RE: Supplement #2 to the Sacramento Cogeneration Authority's Procter and Gamble
Cogeneration Project (93-AFC-2C) Auxiliary Boiler 1B Project Petition to Amend

Supplement 2: Equipment Location

Addition of an Auxiliary Boiler and Associated Facilities

for the
**Sacramento Cogeneration Authority's
Procter and Gamble Cogeneration
Project**

FIGURE S2-1

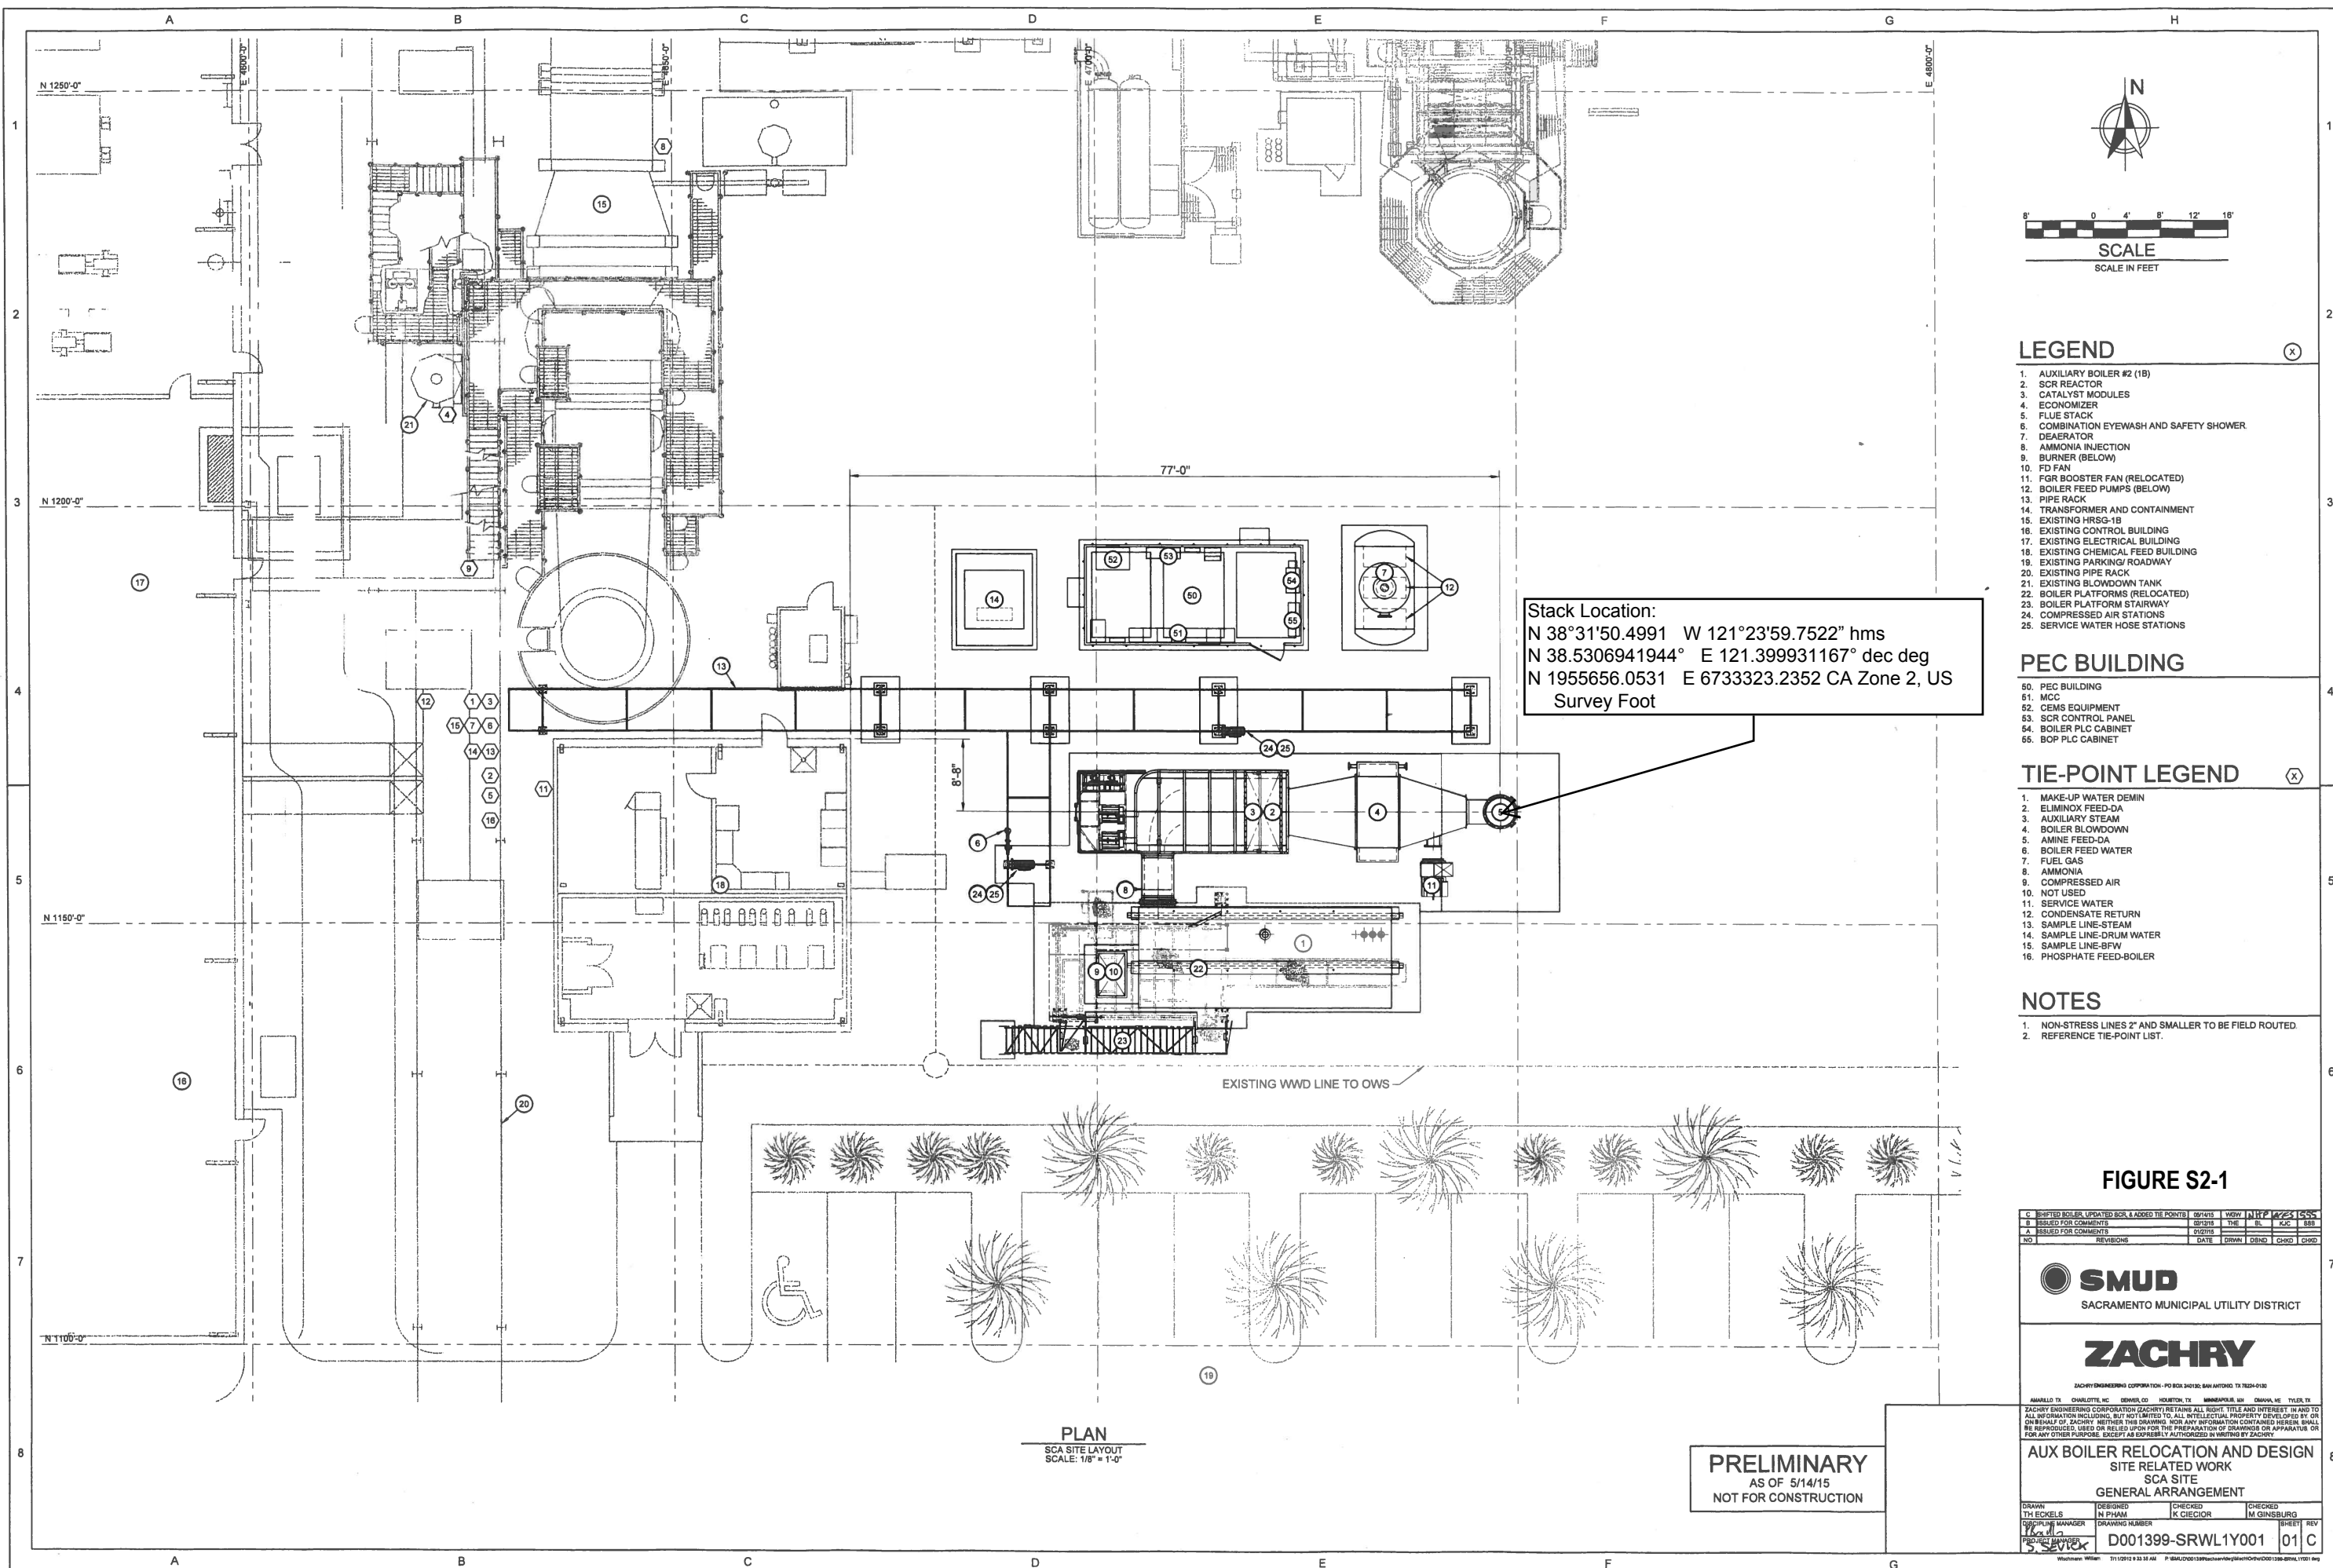
Since the PTA was filed on October 30, 2014 design work on this project has continued to move forward. Figure S2-1 shows the latest general arrangement drawing of the new Boiler 1B at the plant site and provides the coordinates of the stack location. This information does not significantly change the stack location details previously submitted, nor does it affect the conclusions of the air quality analysis regarding insignificant project impacts.

Stack Location:
 N 38°31'50.4991 W 121°23'59.7522" hms
 N 38.5306941944° E 121.399931167° dec deg
 N 1955656.0531 E 6733323.2352 CA Zone 2, US
 Survey Foot
